EXHIBIT F

Possible new feature: Transparent polymer cap to inspect unit functioning.

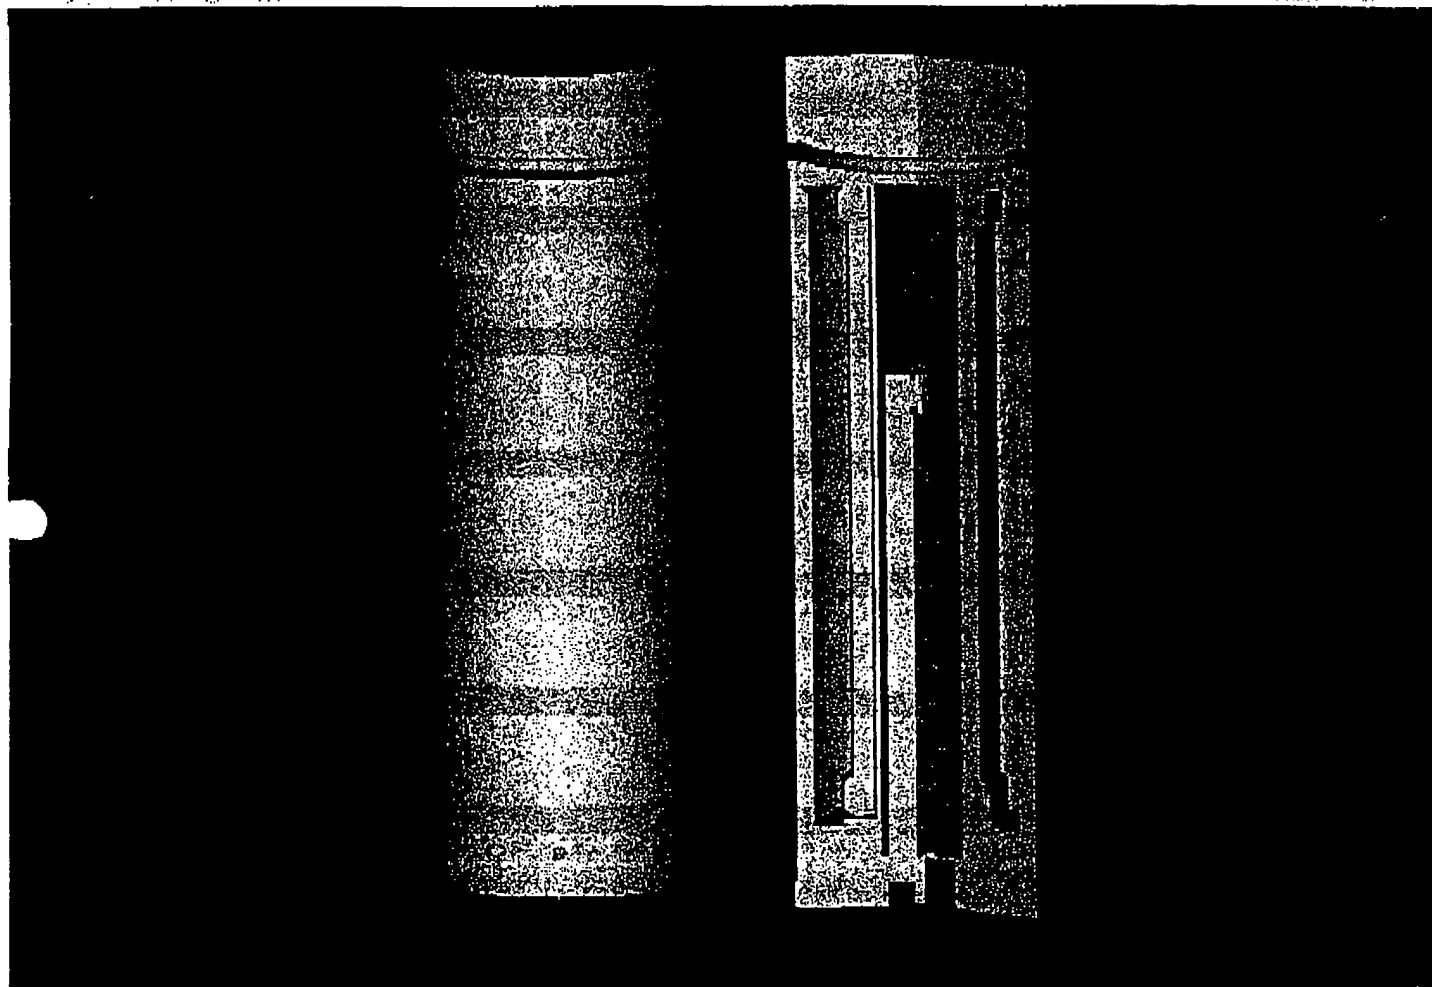
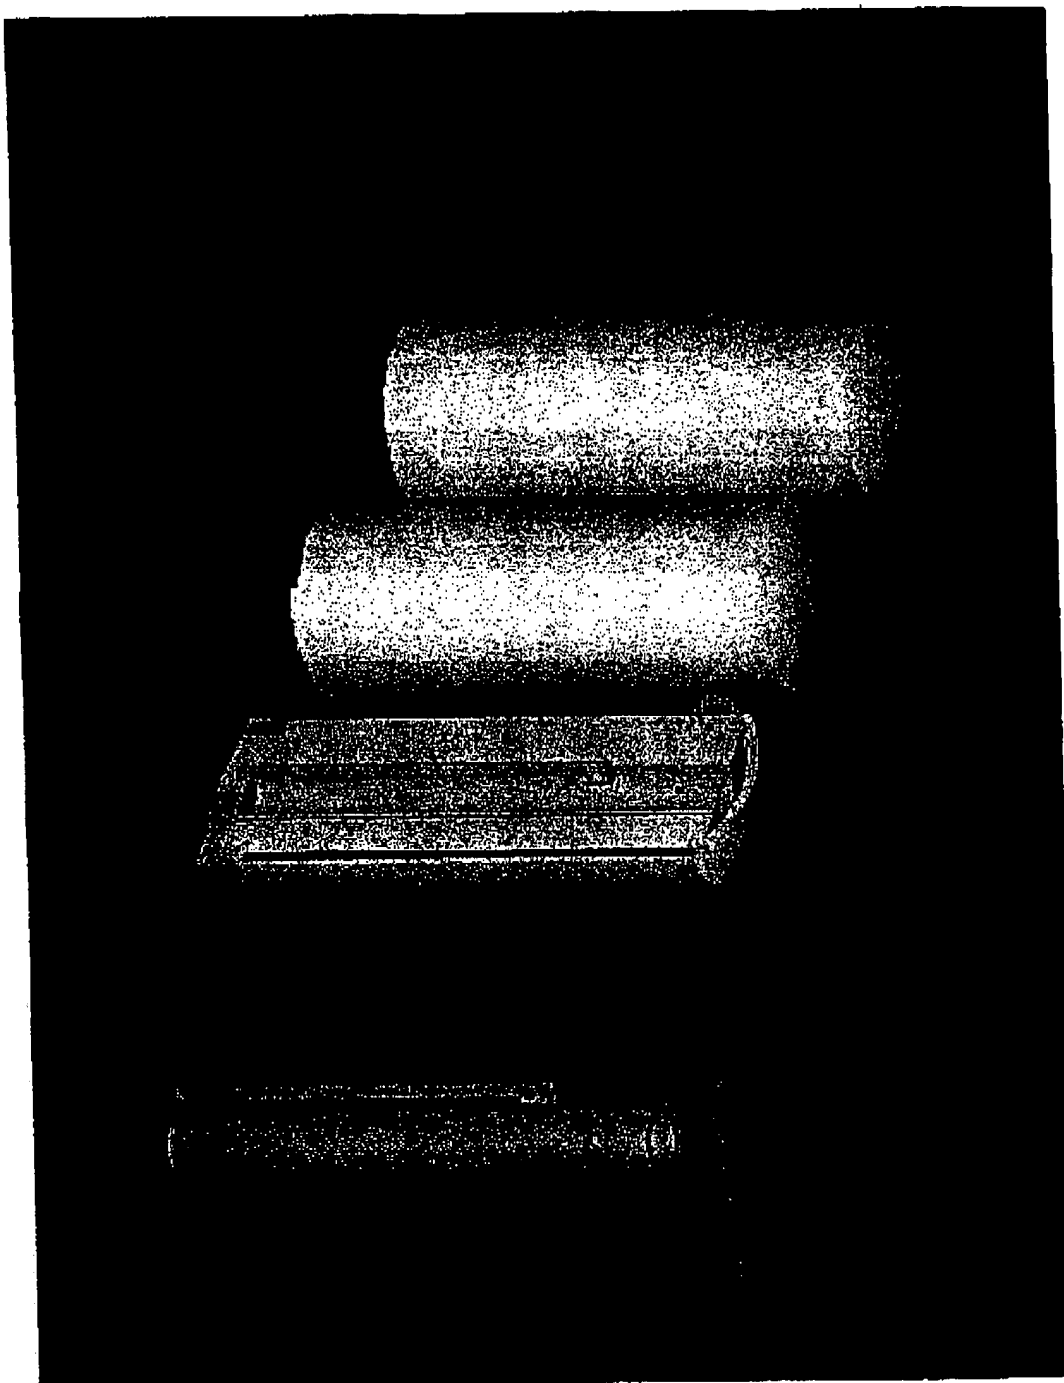
Pressure regulator included?

1. Wasted space bet. filter & housing →
 - a. provide insulative material to occupy space.
 - b. Use centrifugal action of oil flow in space to swing out particles.
 - c. Add extra filter element around mid core.
2. Oil pressure inline lets contaminants drain back to engine.
 - a. provide coiled tube w/ holes for oil exit & dispersion.
 - dispenses heat from incoming oil, providing less element melting.
3. If filter is snug against evaporation tube, and holes are at top of tube → filter life compromised and oil stagnation results. If oil drains back down through filter (holes at bot. of tube) → easy inspection of filter element.
